**• A D D E N D U M # 2 •**

<b>TO ALL PLAN HOLDERS</b>	<b>DATE</b>	<b>JULY 10, 2015</b>	<b>JOB NO.:</b>	<b>2302-023</b>
	<b>ATTN</b>	<b>Plan Holders</b>		
	<b>RE</b>	<b>City of Newport Ferry Slip Road Improvements</b>

**4**  
E2 JOINT TRENCH DETAIL  
NOT TO SCALE

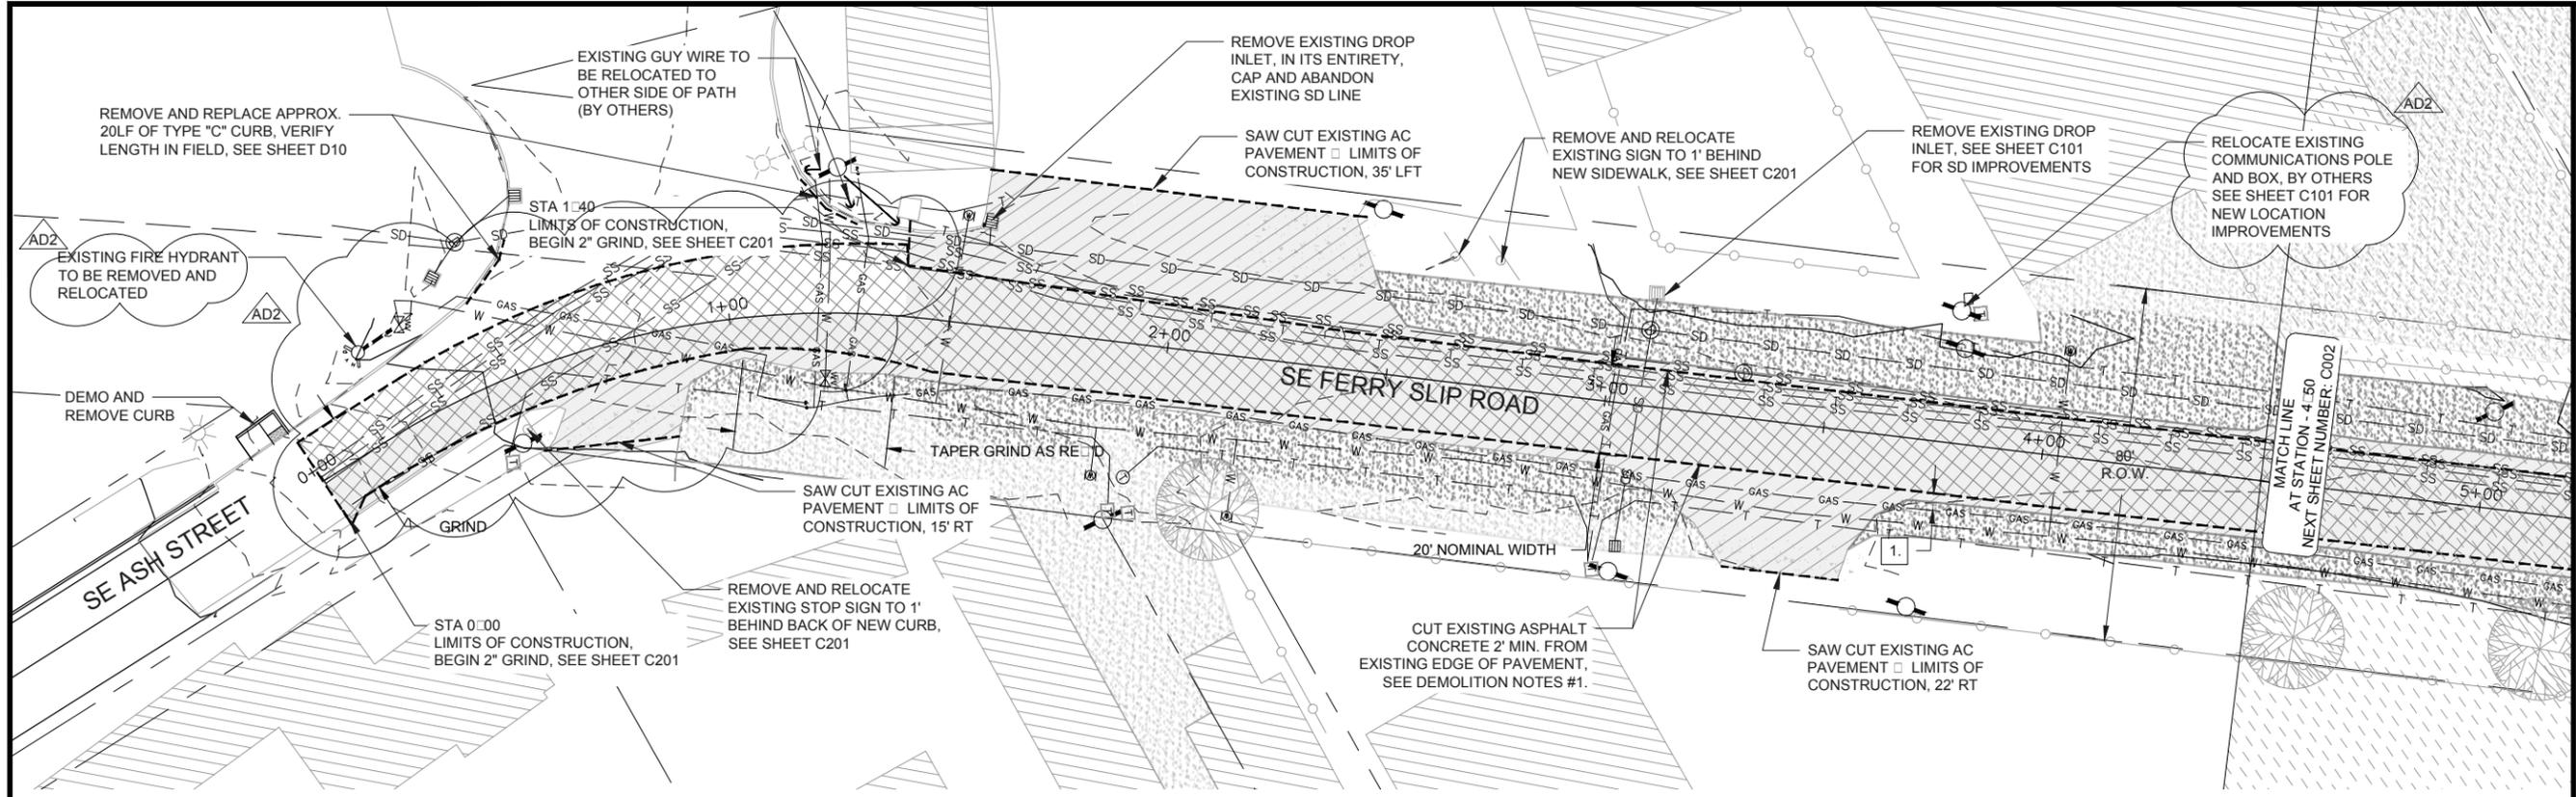
22. C401- Added Standard Crosswalk
23. E1- Moved Acorn light at Sta 4+35 to Sta 4+18
24. E2- Added Joint Trench Detail 4/E2 for placement of new utility lines.

DEMOLITION PLAN STA 0+00 TO 4+50  
1" = 40'

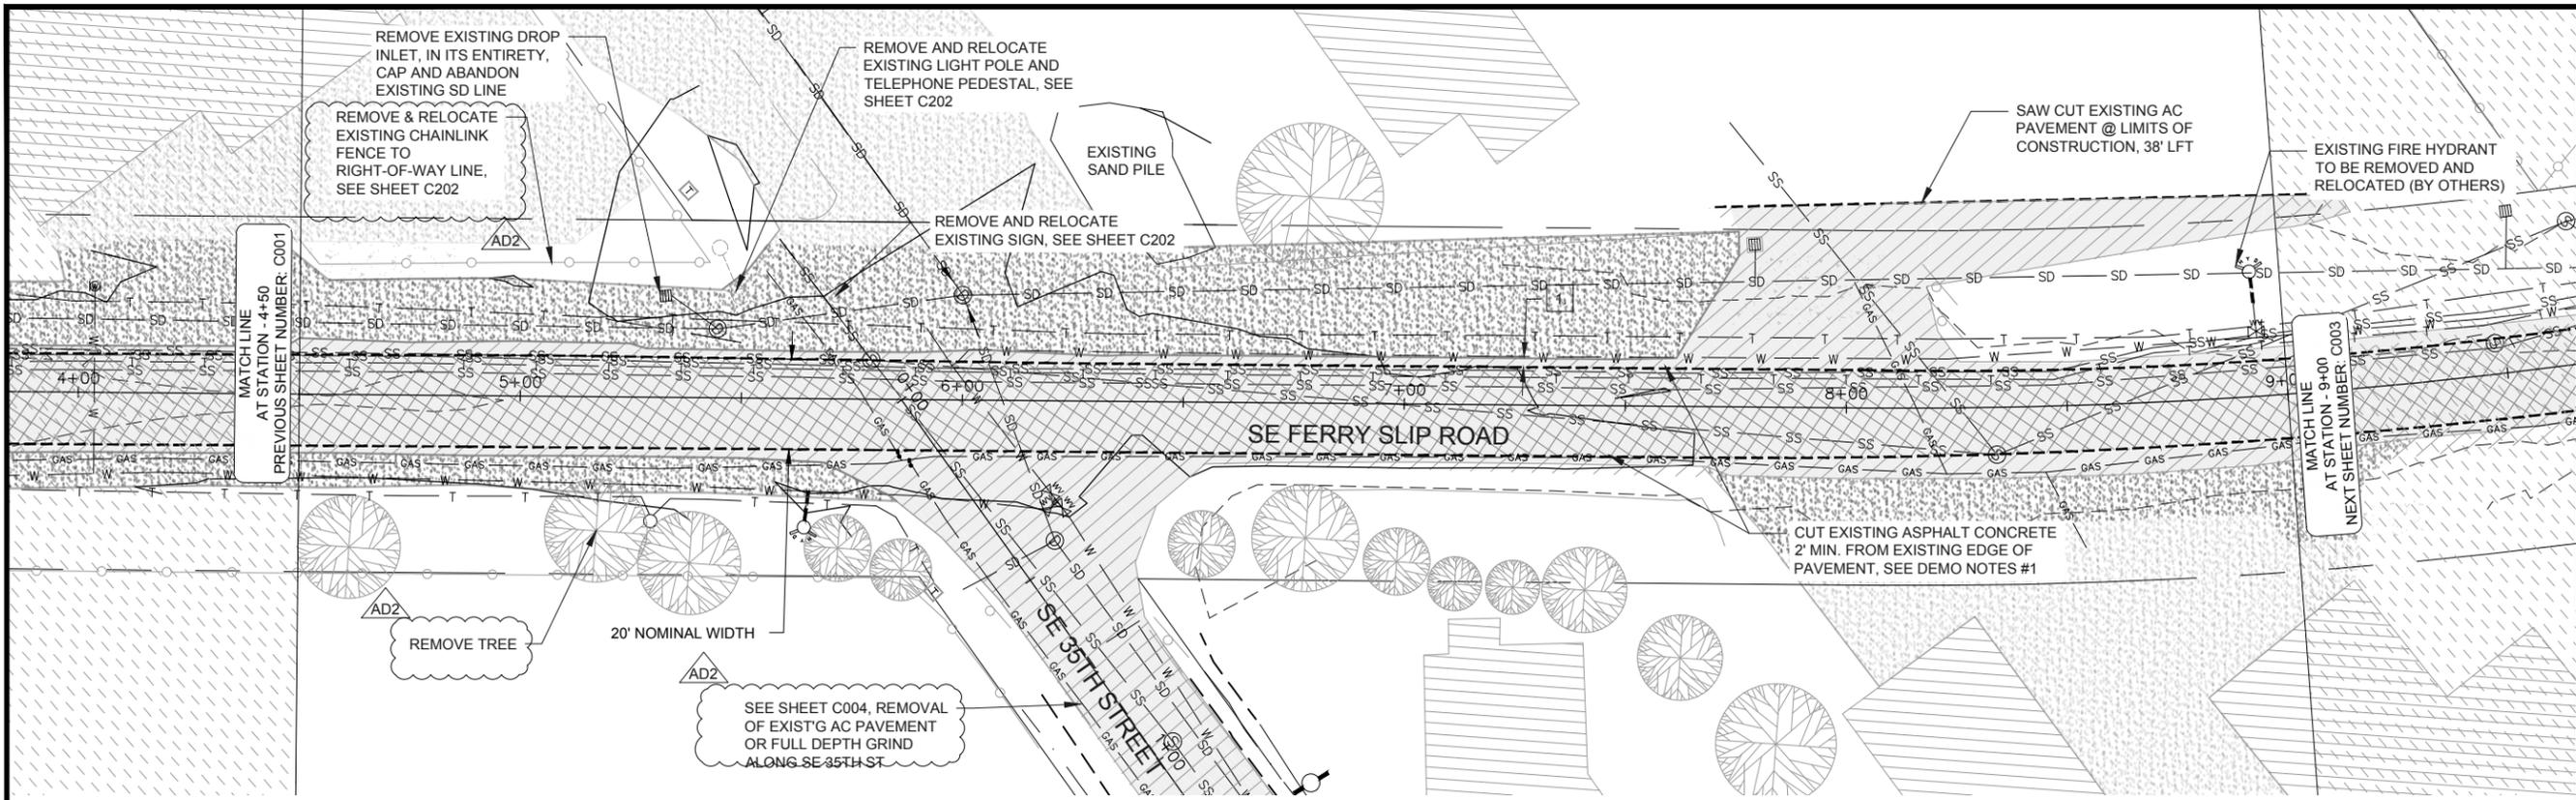
1. C001- Delete “BY OTHERS” from “existing fire hydrant to be removed and located” callout.

2. C001- Extend grind area and AC overlay on west side of Ferry Slip Road at Ash Street to meet East side grind and AC overlay.
3. C001- Add "BY OTHERS" to "Relocate existing communications pole and box, see sheet C101 for new location of improvements" callout.

4. C001- Add Sta 0+00 to Sta 4+50 to Note 2.
5. C002- Add "TO RIGHT-OF-WAY LINE" TO "Remove and relocate existing chainlink fence..." Callout.
6. C002- Add callout "REMOVE TREE".

DEMOLITION PLAN STA 4+50 TO 9+00  
1" = 40'

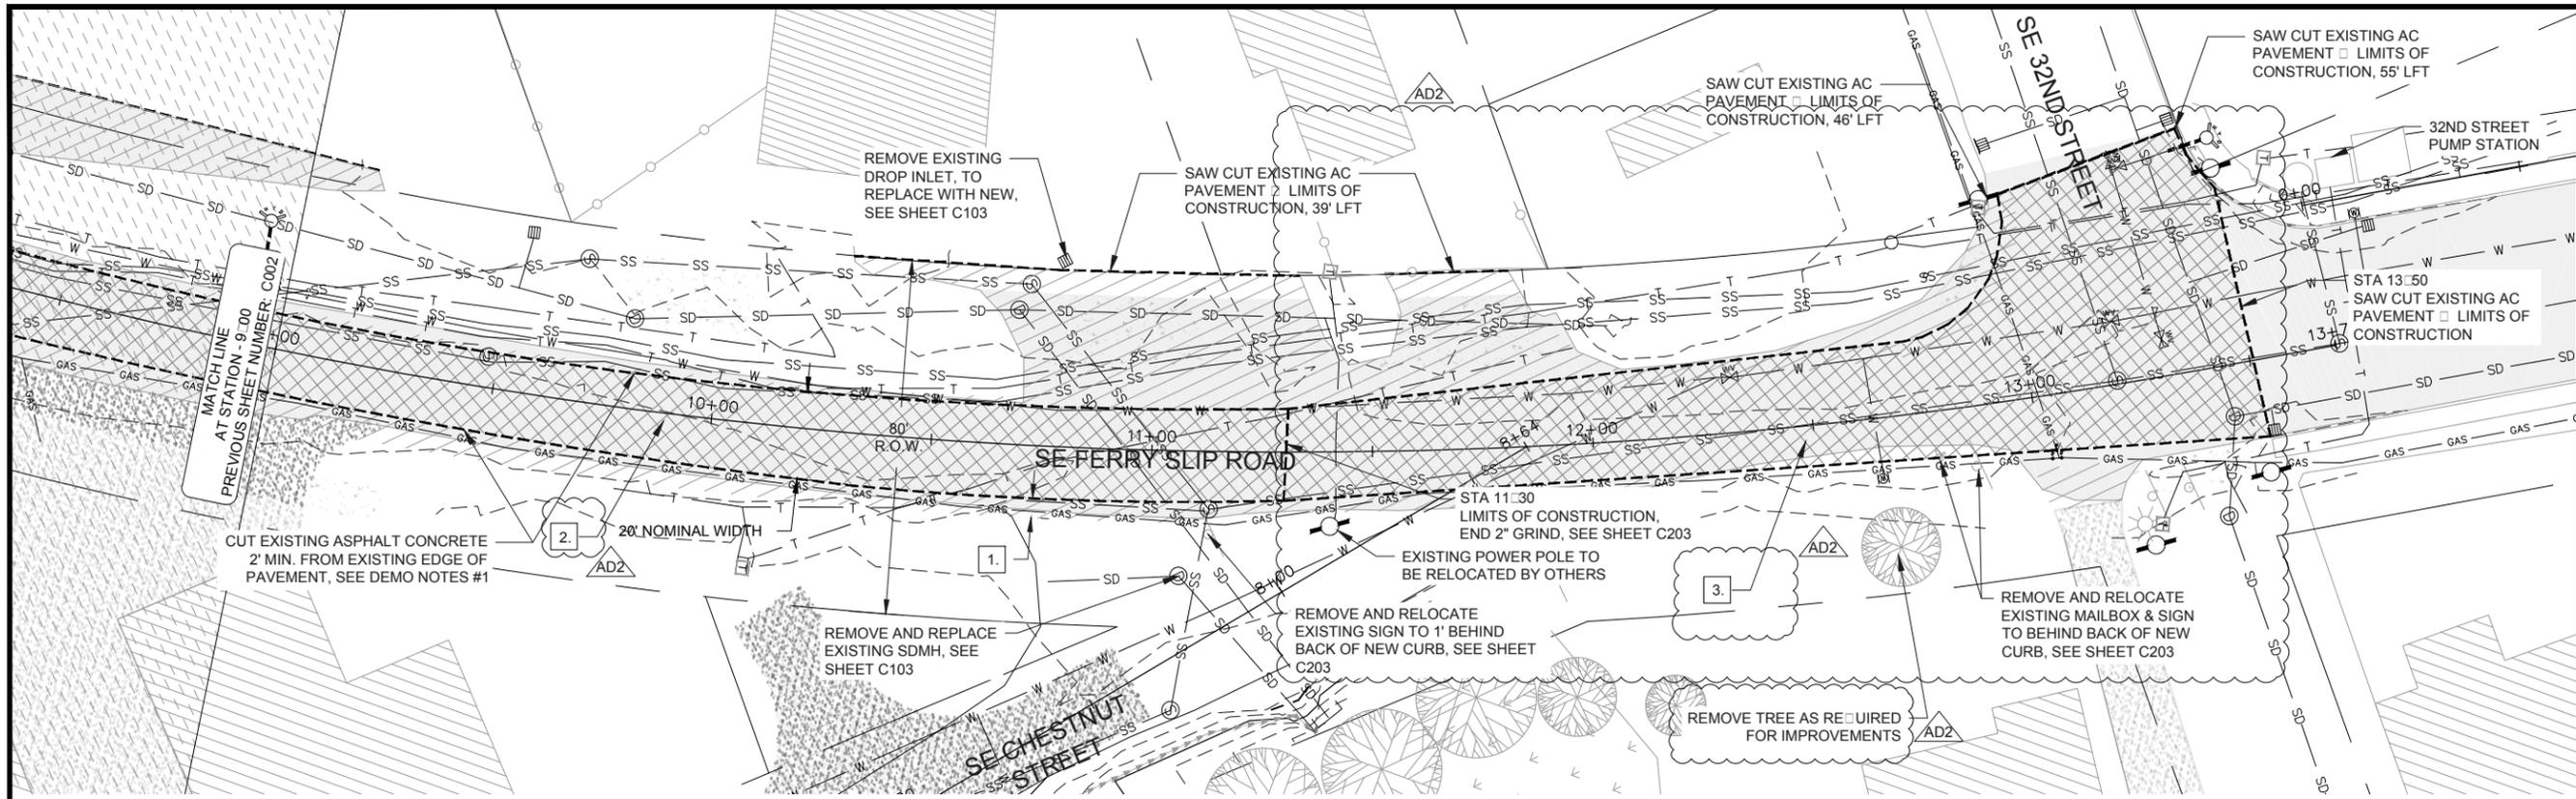
7. C002- Add "OR FULL DEPTH GRIND" to "See sheet C004 removal of existing AC..." Callout.
8. C002- Add "Sta 4+50 to Sta 9+00" to Note 2.
9. C003- Move note 2 callout to Sta 10+00.

DEMOLITION PLAN STA 9+00 TO 13+65  
1" = 40'

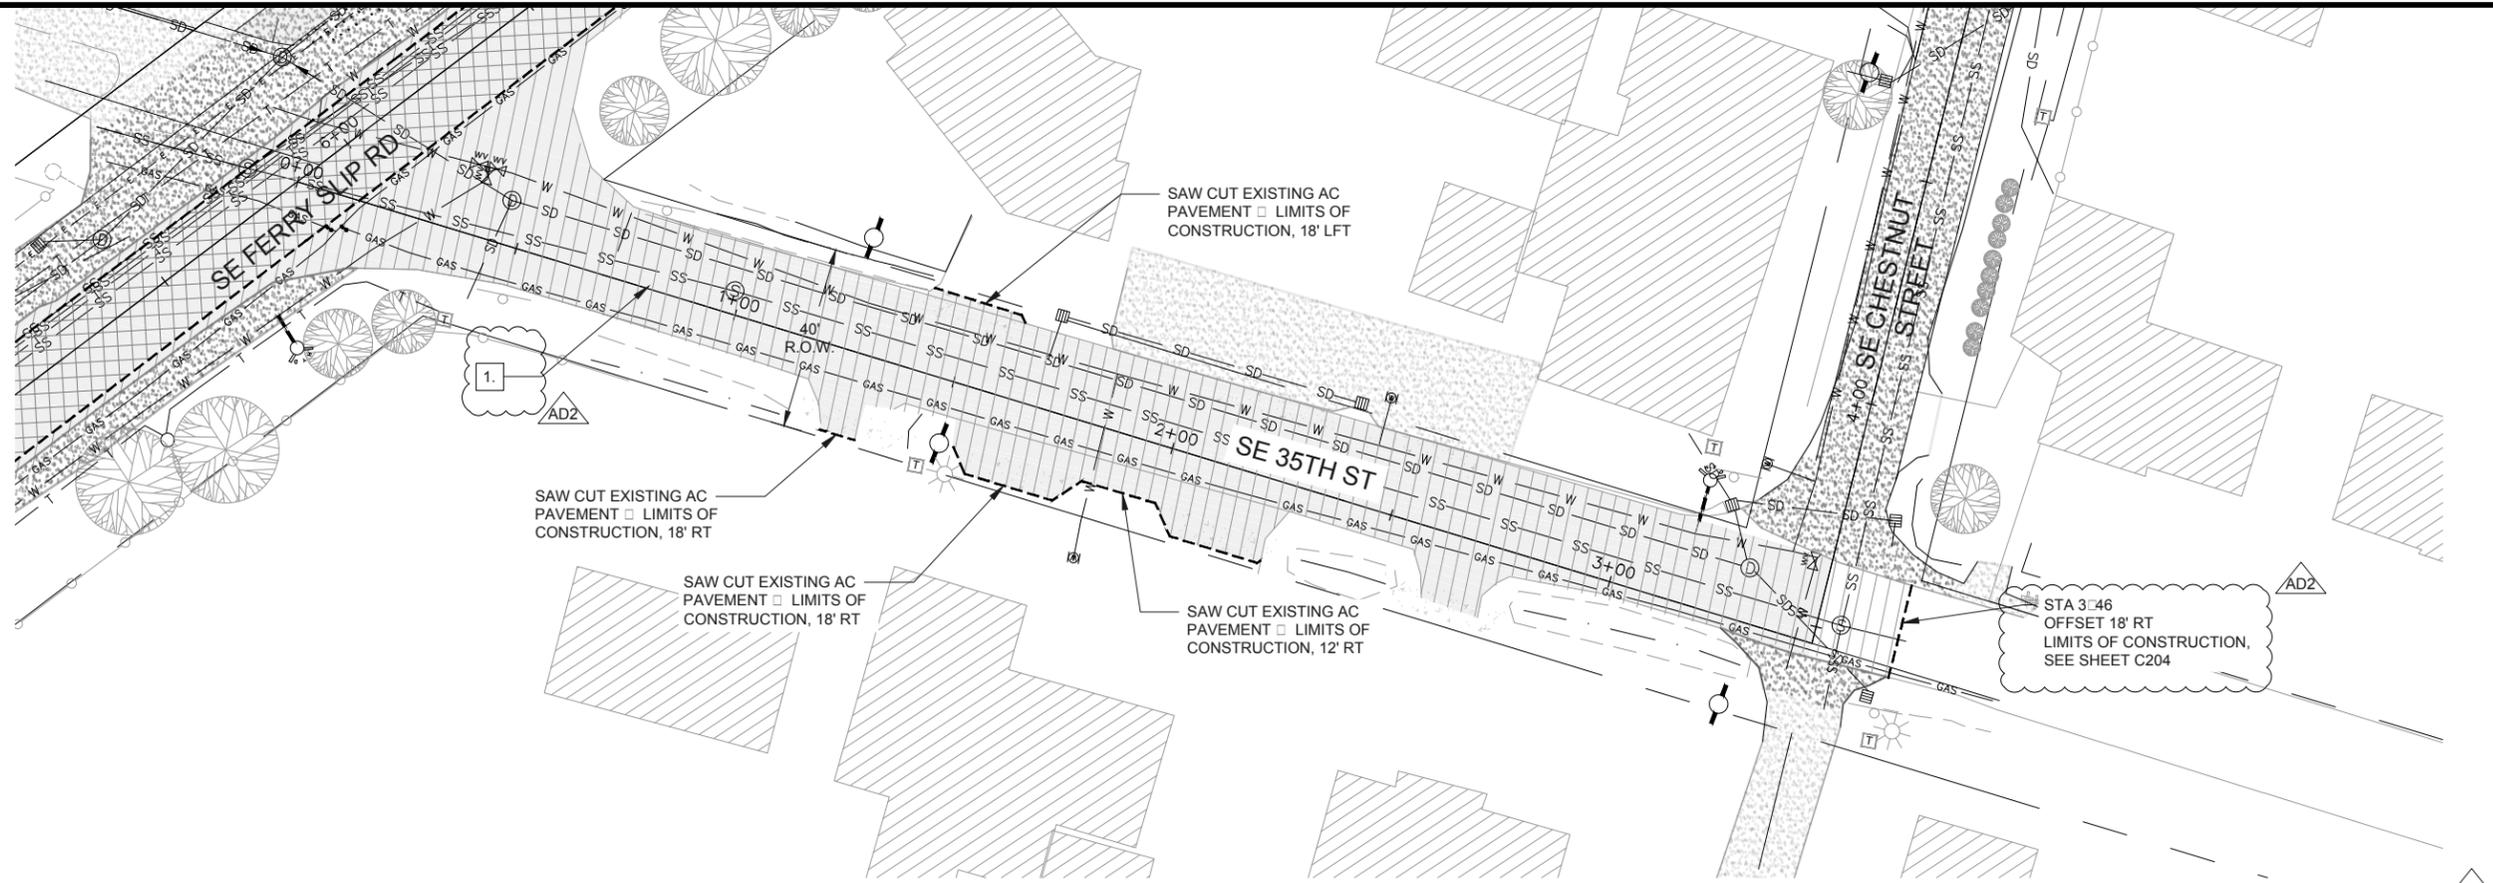
10. C003- Add Note 3 and Callout at Sta 12+50.
11. C003- Add callout "REMOVE TREE AS REQUIRED FOR IMPROVEMENTS".
12. C003- Delete removal hatch and add grind hatch from Sta- 11+30 to 13+50.

13. C003- Add "STA 9+00 TO STA 11+30" to Note 2.
14. C004- Add callout 1 and edit Note 1, Add " OR CONTRACTOR CAN DO FULL DEPTH ASPHALT GRIND STA 0+14 TO STA 3+46"

**1** SE 35th & CHESTNUT ST - STA 0+00 TO 4+50 GRADING PLAN  
**C004** 1" = 40'

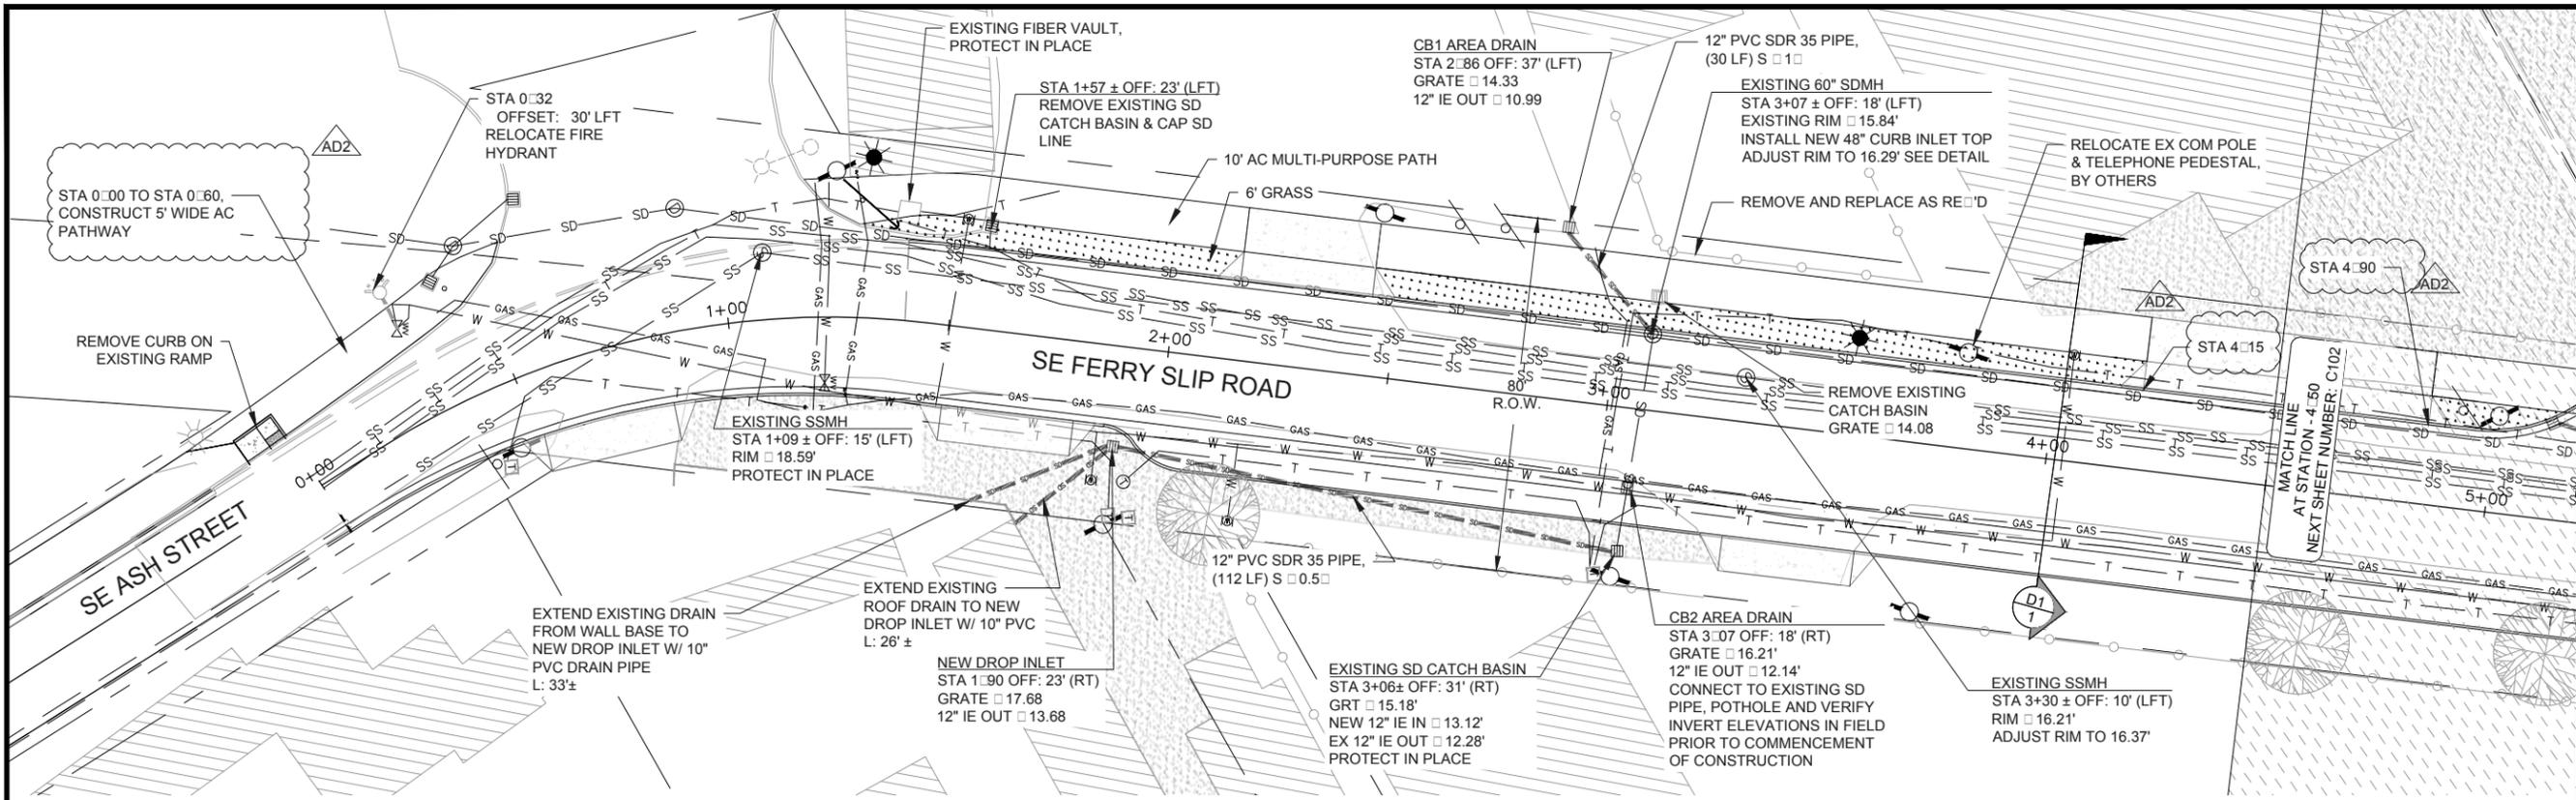
15. C004- Delete "END 2" GRIND" from "Sta 3+46 offset 18' rt..." callout.
16. C101- Add 5' AC pathway from Sta 0+00 to Sta 0+60.
17. C101/C201/C202- Increase driveway size to 75' and move to Sta 4+52.
